**PREPARED TESTIMONY OF RICHARD KUPREWICZ
EVALUATING PG&E'S PIPELINE SAFETY ENHANCEMENT
PLAN**

**CALIFORNIA PUBLIC UTILITIES COMMISSION
PIPELINE SAFETY RULEMAKING
R. 11-02-019**

**Submitted on behalf of
THE UTILITY REFORM NETWORK (TURN)**

Figure 1: Number of Miles Scheduled for Strength Testing by PG&E's Decision Step Output

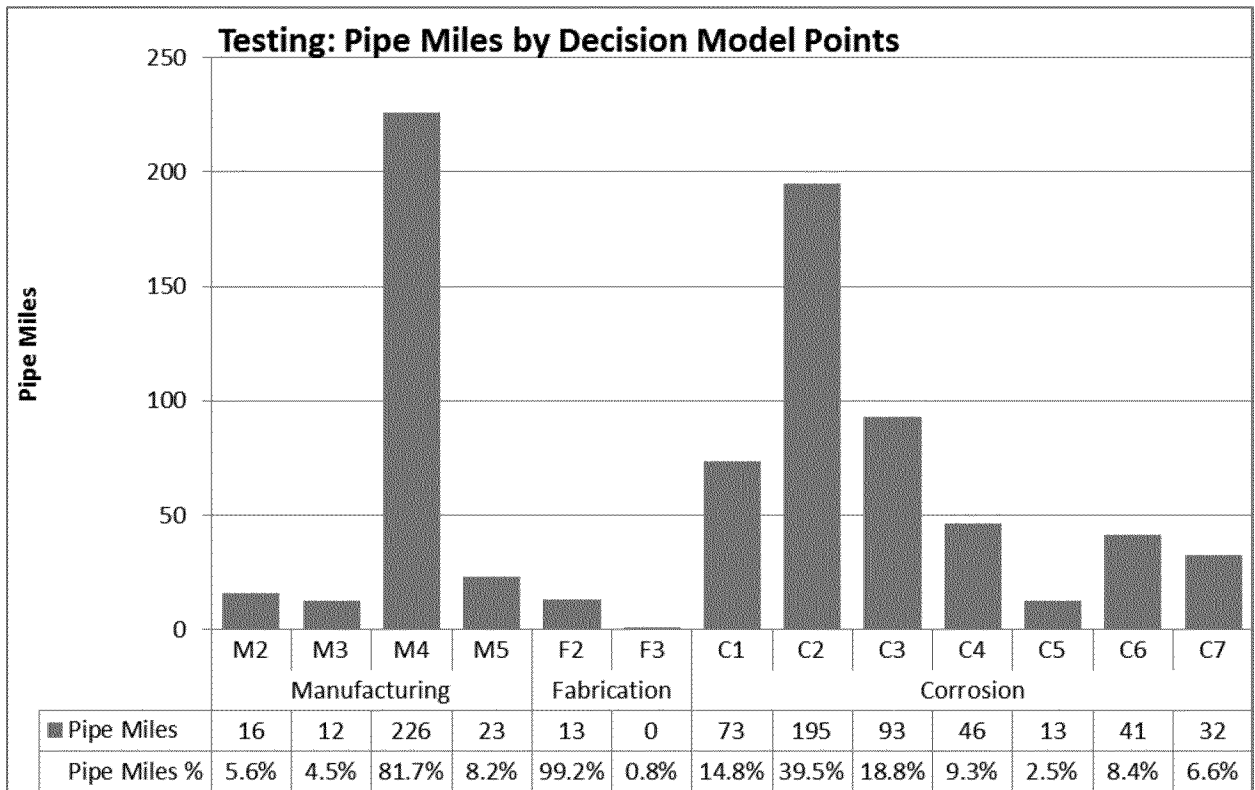
- Corrosions Threats: The Decision Tree needs to be revised. For the 493 miles PG&E is proposing to be scheduled for testing due to the corrosion decision tree (see Figure 1), I recommend that ILI is a better assessment tool if the pipe can be retrofit for piggability. Prudent leak survey analysis, however, will be a better assessment approach for the lower stress (< 30 SMYS) segments where corrosion/third party damage is the only threat of concern. I do not recommend relying on any of PG&E's past integrity management outcomes.

TURN believes the majority of pipeline meeting step M2 should be able to be hydrotested. Step M2 in PG&E's plan results in 100 miles of pipe replacement. I estimate that a very high percentage of this pipe, on the order of 95 +%, or 95 plus miles, would pass a prudent hydrotest and should not be replaced.

Figure 2: Number of Miles Scheduled for Replacement by PG&E's Decision Step Output

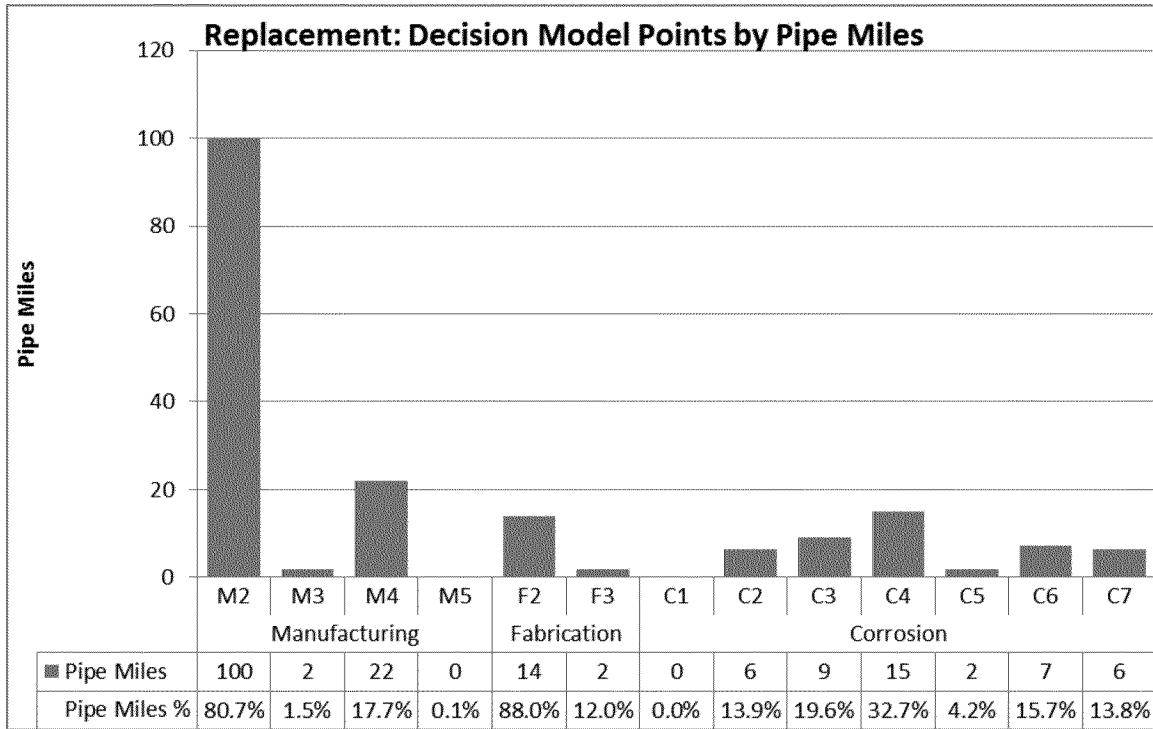
For example, over 100 miles of replacement result from PG&E's Decision Tree Step M2. Step M2 results in a decision to replace large diameter (during Phase 1) Urban pipe with manufacturing threats that operate at >30% SMYS. Step M2 should be modified to say, "Reduce Pressure & either Strength Test or Replace in Phase 1." If the line can survive a prudent hydrotest the extreme of replacement for seam weld threats needs to be specifically justified. Before proceeding to a replacement decision other steps should be added asking or indicating what critical factor(s) drive to replacement over hydrotesting or ILI? For example does the pipeline segment contain at -risk manufacturing seam factors that hydrotesting or ILI cannot adequately assess? And more importantly is there a problem with the pipeline segment that has led PG&E to determine that a specific pipe segment would experience numerous hydrotest failures that would justify pipe replacement? Could the pipeline be rationally shutdown for hydrotesting or ILI conversion? (if not, then pipe replacement may be warranted).

Figure 3: TURN’s Proposed Flow Diagram Replacing Steps 2F, 2G, F2 & F3 in PG&E Pipeline Modernization Decision Tree

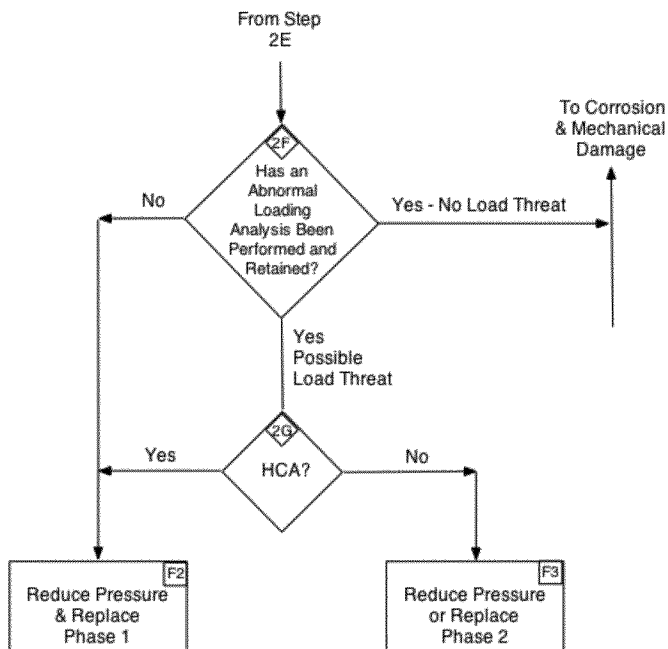
TURN proposes that steps 2F, 2G, F2 and F3 be replaced as indicated in Figure 3. This alternate decision tree introduces another step to determine whether an “abnormal loading analysis” has been performed. Segments where the abnormal loading analysis has shown that there are no load threats can pass the Fabrication and Construction Threats tree, but should be added to a list of segments that PG&E should periodically monitor in their right-of-way program to assure the abnormal loading threat conditions haven’t changed.

Figure 4: TURN's Proposed Decision Tree for Corrosion and Mechanical Latent Damage

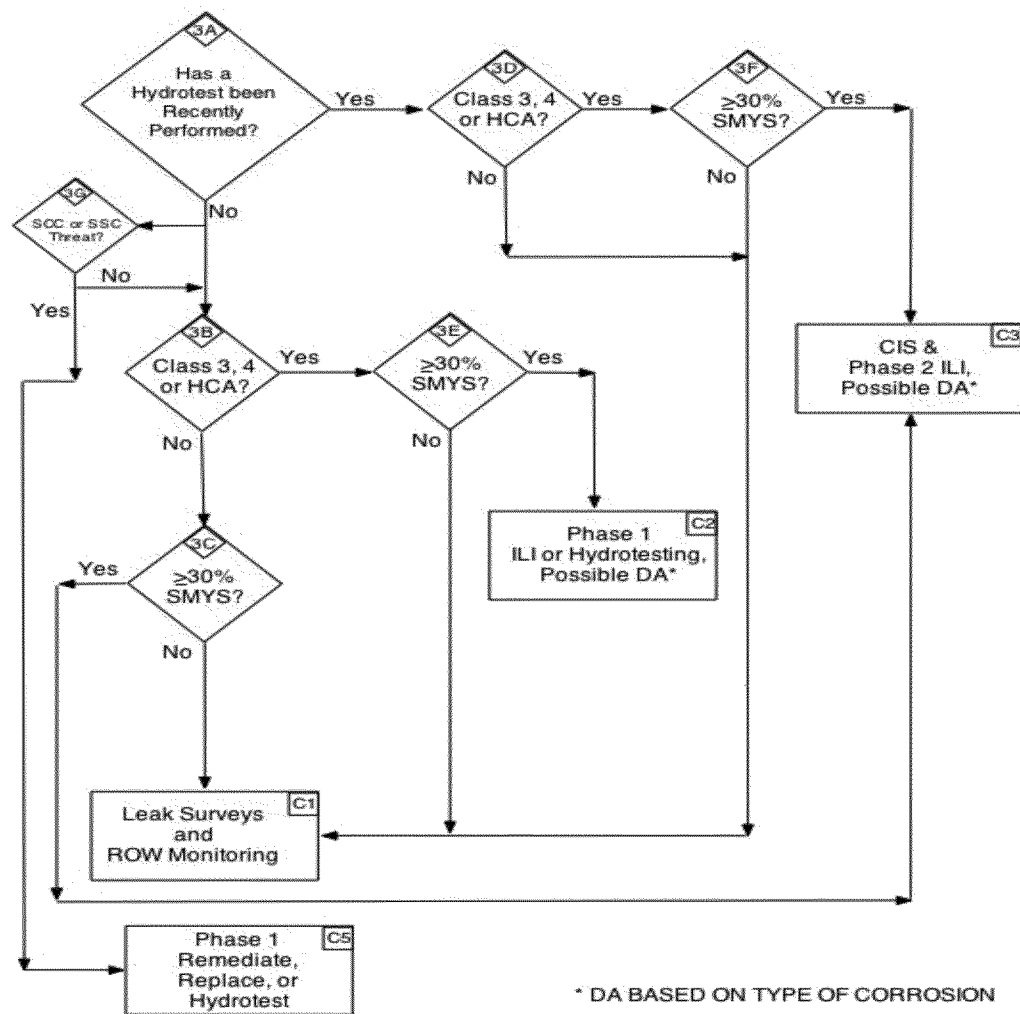
Figure 4 is TURN's proposed flow diagram for this threat category that we believe is more appropriate and that should replace PG&E's PM Decision Tree for pipeline segments containing only this family of threats. Comparing Figure 4 to PG&E's Attachment 3A illustrates another problem when approaching pipeline threats utilizing a sequential flow diagram method. The conclusion may not make sense (such as suggesting hydrotesting or ILI for transmission pipelines that are much more likely to leak, rather than rupture), or might miss important threat considerations, such as Stress Corrosion Cracking, ("SCC"), or selective seam corrosion, ("SSC"), specialized forms of selective corrosion that usually

Figure 4. TURN is basically recommending for non urban areas, as well as urban areas both operating at < 30% SMYS step C1, that efforts be focused on leak monitoring/evaluation and prudent right-of way monitoring, unless these segments can cost effectively be converted to ILI over time.

Figure 5: Blowdown Time, reproduced from PG&E Figure 4-7

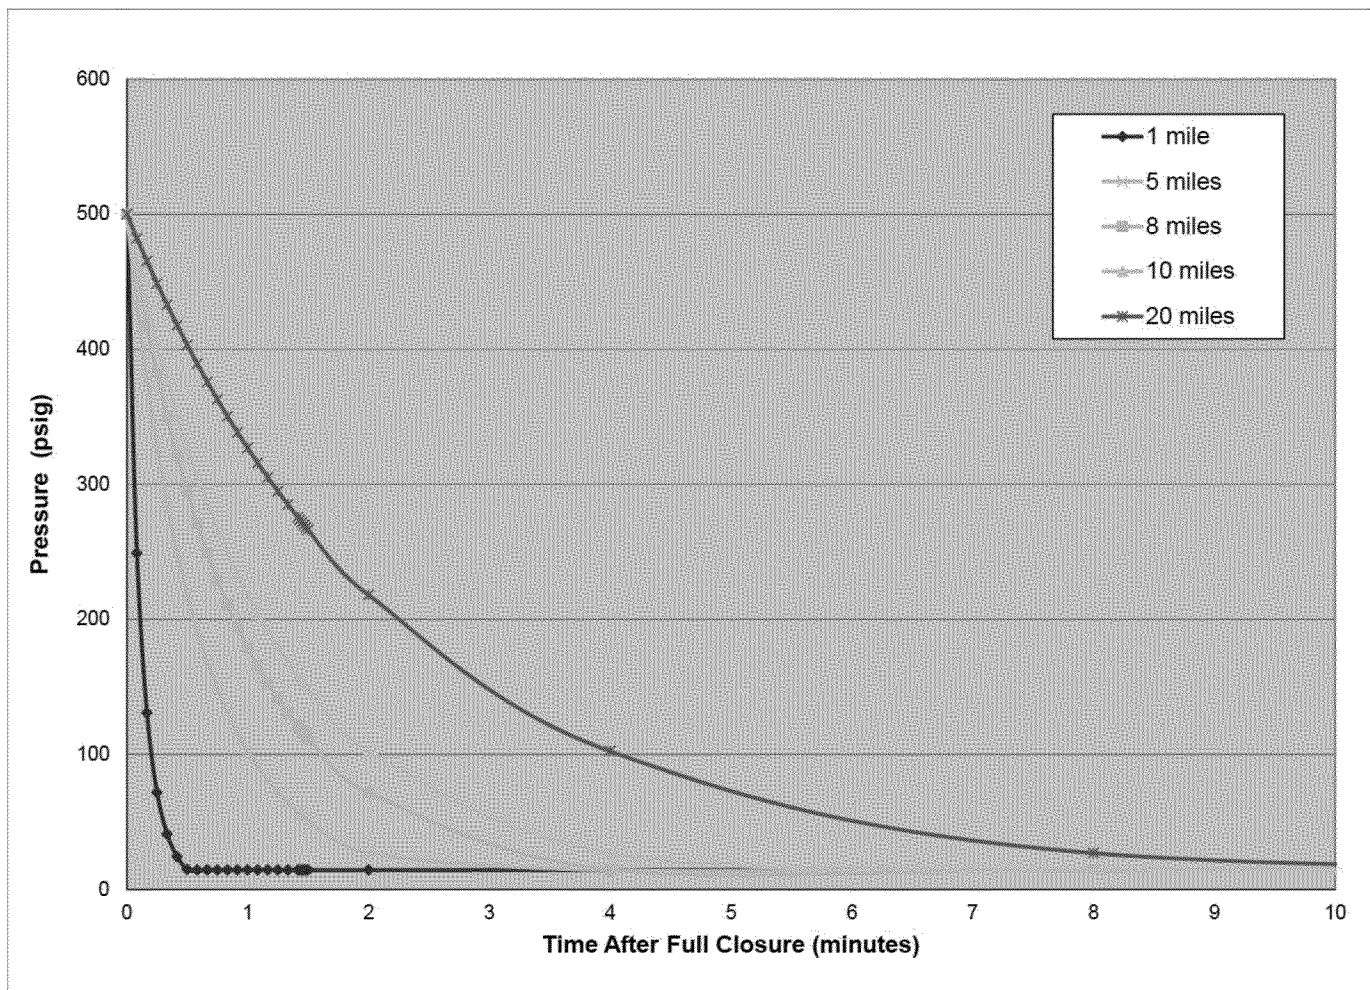
Figure 5 reproduces Figure 4-7 from PG&E'S Testimony. This figure is incomplete, as it is missing critical information, such as pipe diameter, and seriously understates the isolation blowdown release times for gas transmission pipelines following rupture. The figure attempts to identify blowdown times but fails to accurately portray such times for gas transmission pipeline ruptures. PG&E apparently developed this figure for one particular pipeline diameter - a 12-inch pipe - and the calculation method used by PG&E's experts is unsuitable for long transmission pipelines.⁵¹ The approach used by PG&E to estimate blowdown times for gas transmission pipelines ruptures to develop PG&E's Figure 4-7 is very inappropriate and should not be utilized for valve decisions on long gas transmission pipelines as pipe length, diameter, and friction factor play a substantial role in estimating rupture release impacts with time.

Figure 6: Actual rupture pressure vs time, 18-inch pipeline

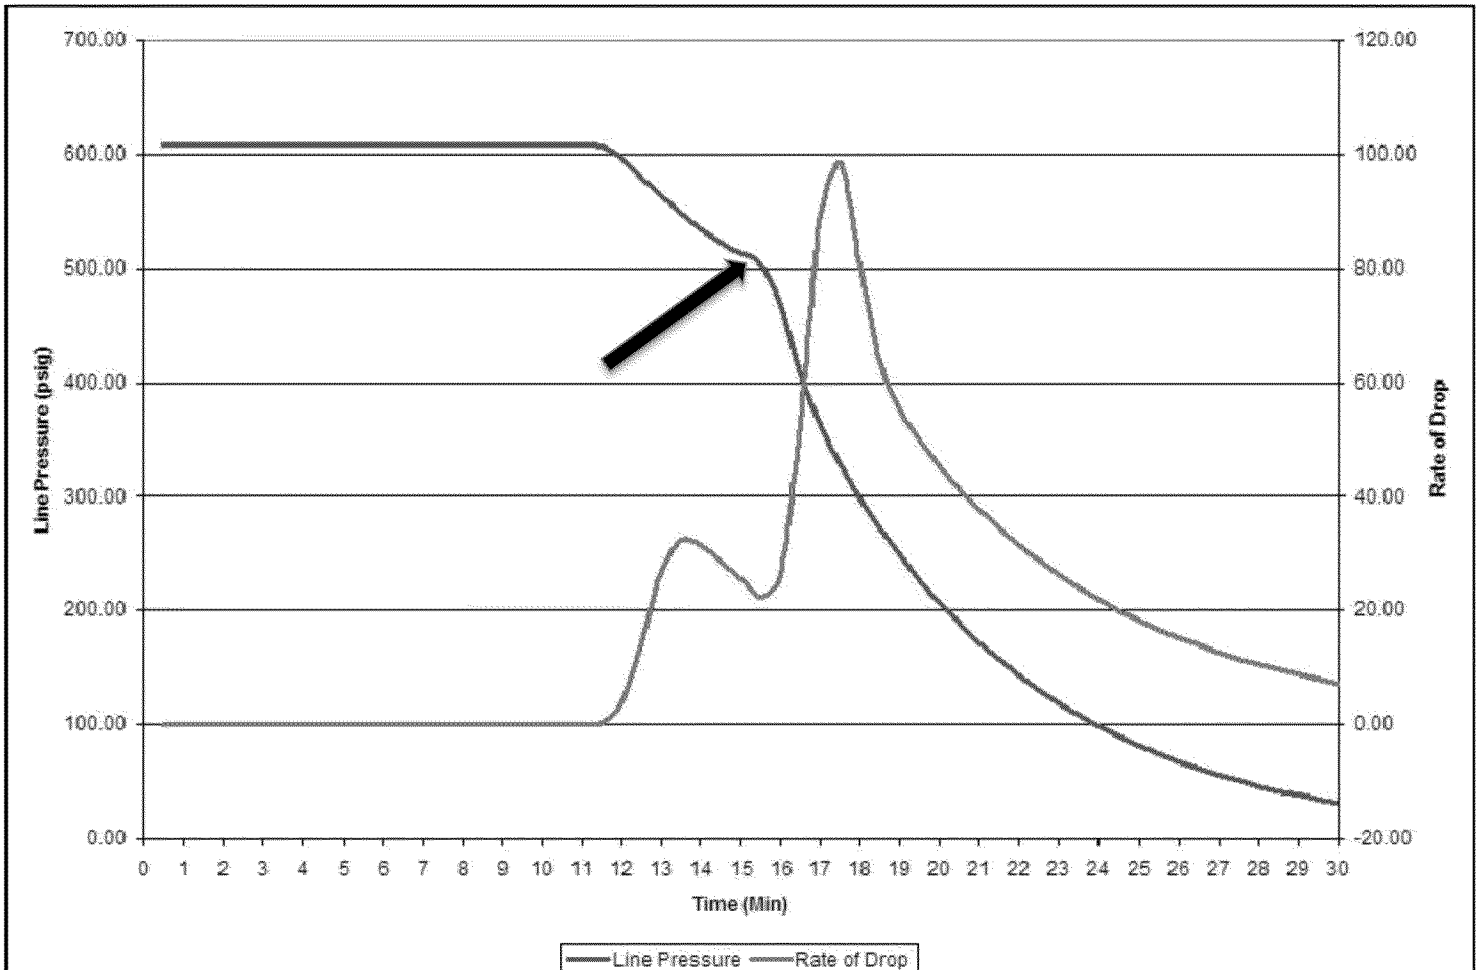
A plot of an actual measured blowdown (pipeline pressure versus time) associated with an 18 -inch gas transmission pipeline rupture involving ASVs spaced ten miles apart, was provided in the testimony of Sempra and is reproduced as Figure 6.⁵² Sempra has indicated that the ruptured pipeline was 7.2 miles from the ASV and the pressure measurement point indicated in Figure 6.⁵³ The actual blowdown time measured from when the ASV closed (see arrow at 500 psig) to approximately 40 psig is about 14 minutes, considerably more time by a factor of 3.5 times than that suggested by PG&E's Figure 4-7 above.

Figure 7 also indicates that for an 18-inch pipeline with a 7.2 valve spacing (see Figure 6), blowdown times for calculated vs actually measured time are comparable correcting for the higher initial pressure of 1000 vs 500 psig.

Figure 7- Isolation Blowdown Time for Gas Transmission Pipeline Ruptures as a Function of Valve Distance from Rupture and Pipe Diameter

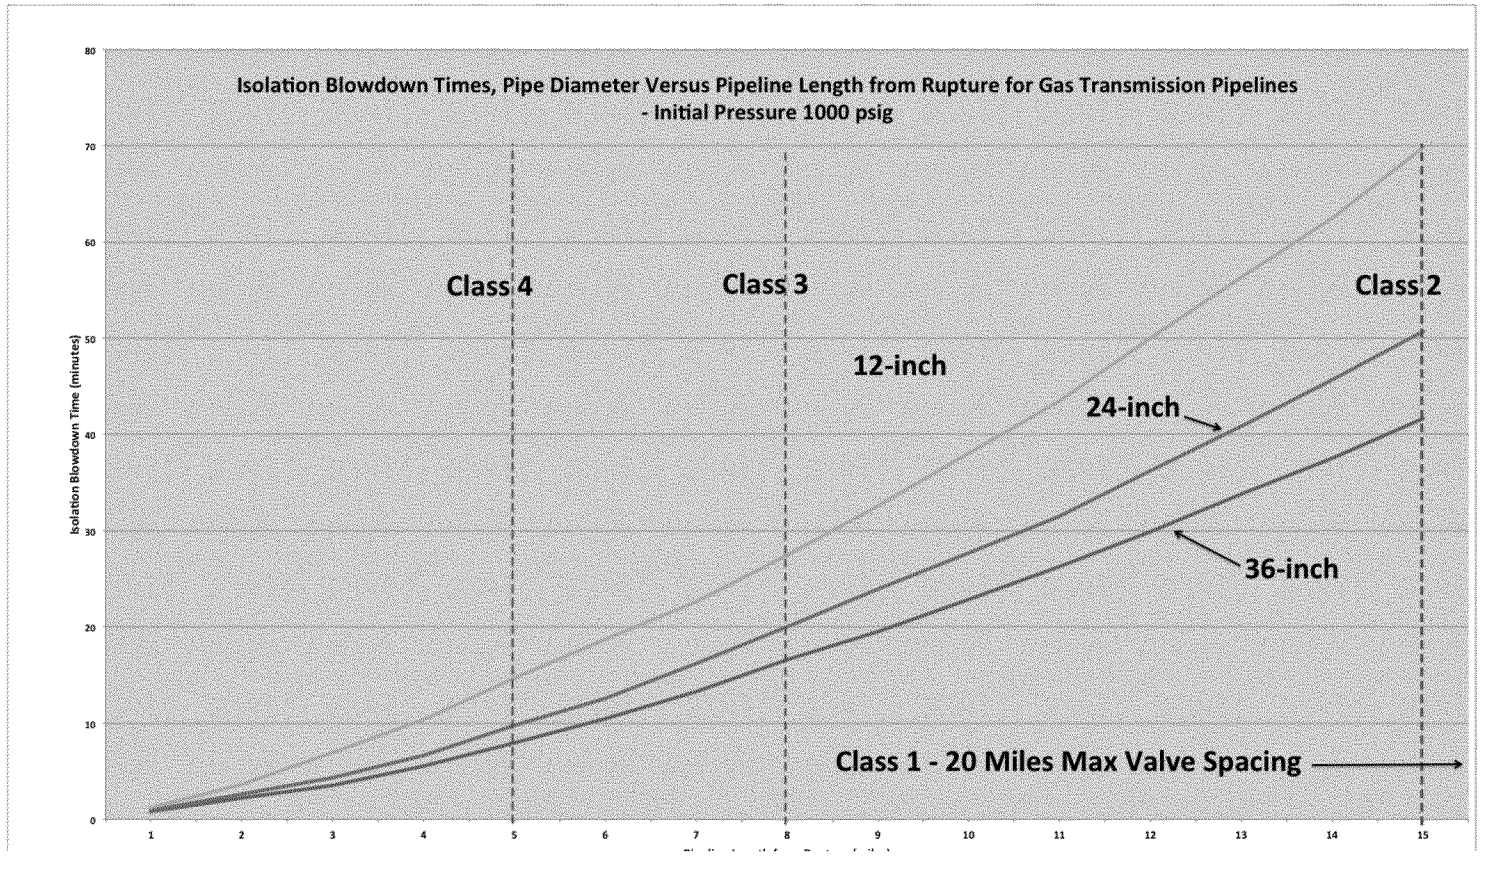
Figure 7 contradicts PG&E's testimony that "A full line break with eight mile spacing with a pipeline starting pressure of 1000 psig is estimated to blowdown in five minutes."⁵⁶ Figure 7 indicates blowdown times significantly greater than five minutes, regardless of the pipe diameter. PG&E needs to explain this serious discrepancy, and provide an appropriate engineering analysis representing transient compressible flow in transmission pipelines that can be independently publically reviewed and confirmed.

Figure 6 and Figure 7 indicate that valve spacing plays a much greater role in isolation blowdown times than indicated by PG&E's testimony. Isolation blowdown times clearly impact decisions related to valve spacing and valve automation.

Figure 9: PG&E Valve Decision Tree

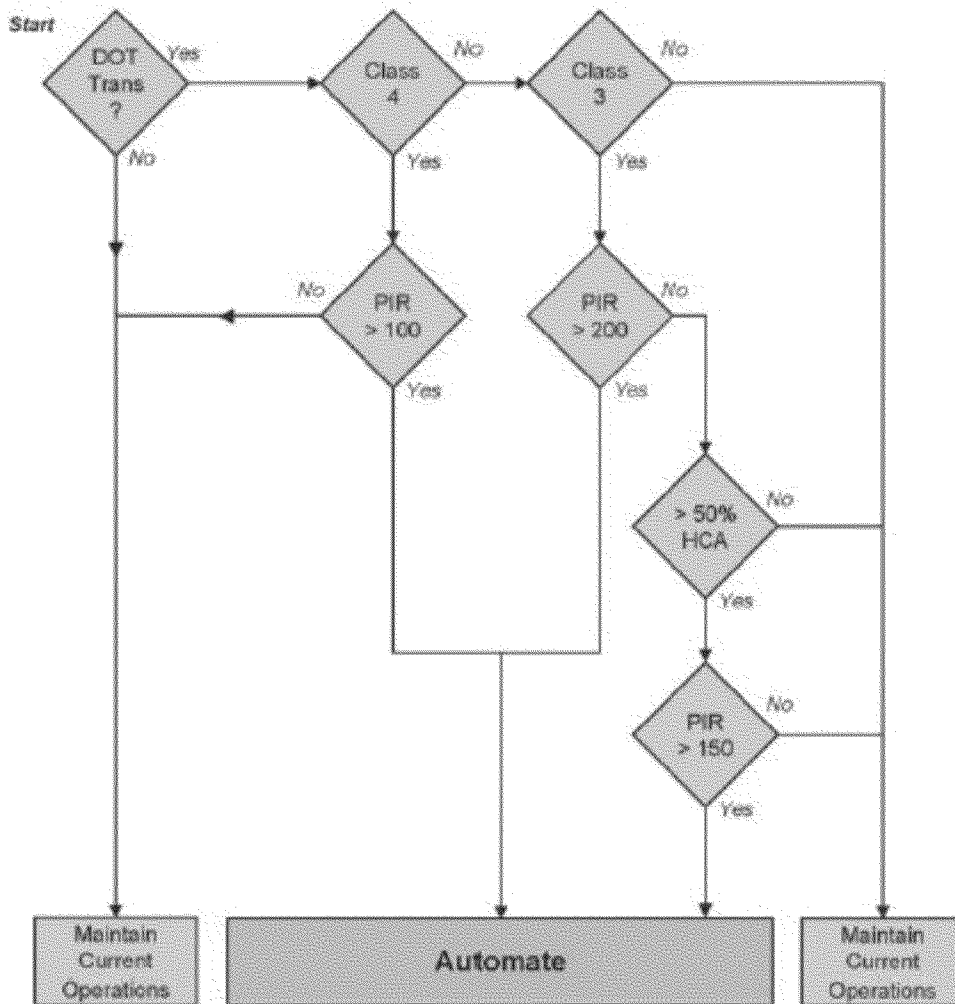
PG&E’s decision trees, which are reproduced as Figure 9 and Figure 10 below, are inadequate.⁶⁴ PG&E’S use of the PIR in their valve decision trees does not adequately address the goal of quickly reducing high heat flux times and actual impact zones.
